AMENDMENT OF SOLICITATION/MODIFICATION OF CONTRACT			1. CONTRACT ID CODE	PAGE OF PAGES 1 of 2
2. AMENDMENT/MODIFICATION NO. 1	3. EFFECTIVE DATE 8-Jan-2002	4. REQUISITION/PURCHASE REQ. NO.	5. PROJECT NO. (If applicable)

Missouri River Levee System, Levee Unit L-385
Phase I - Quindar Levees and Stop Log Gap
Phase II - Quindaro - Riverside Levees and Structures

The SOLICITATION is amended as follows:

Project: Missouri River Levee System, Quindaro Levee and Stoplog Gap,
(Levee Unit L-385), Riverside, Missouri

---PLAN VIEW, FIGURE 1---
 PROPOSED 66" SANITARY SEWER
 GATEWELL 6A REVISION

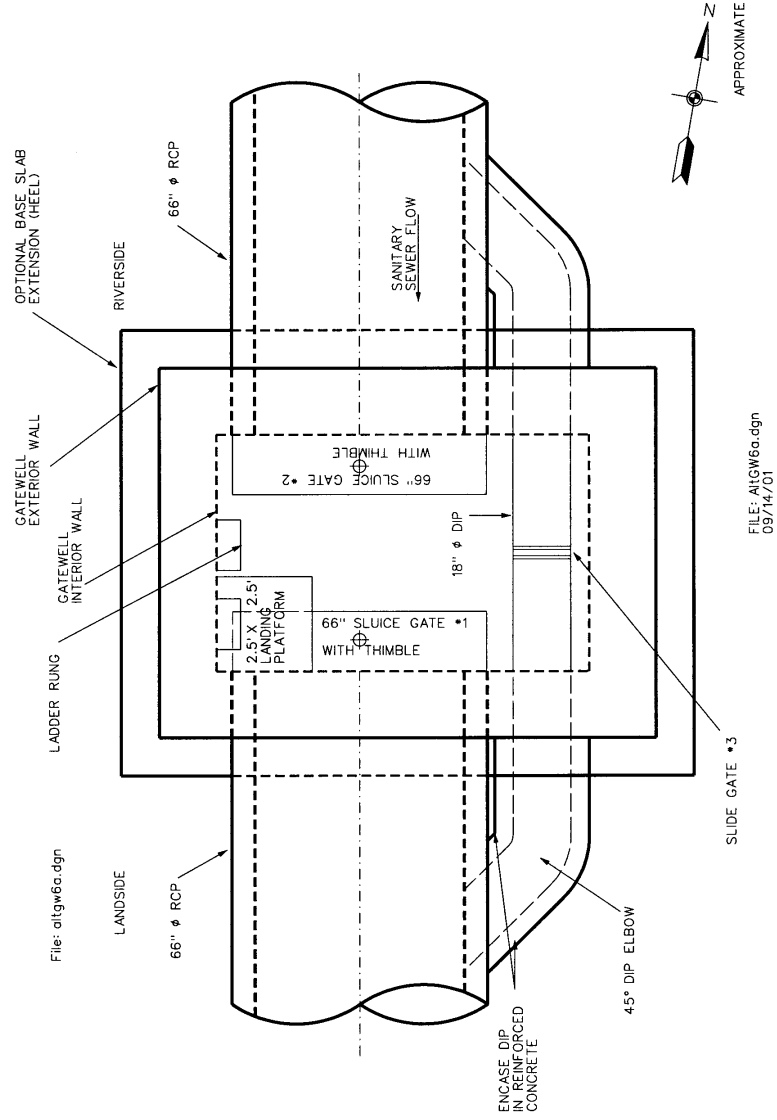
(a) Figure 1 is an insert drawing, titled "Proposed 86" Sanitary Sewer Gatewell 6A Revision", which is inserted after Section 02104. A copy of the insert drawing is attached.
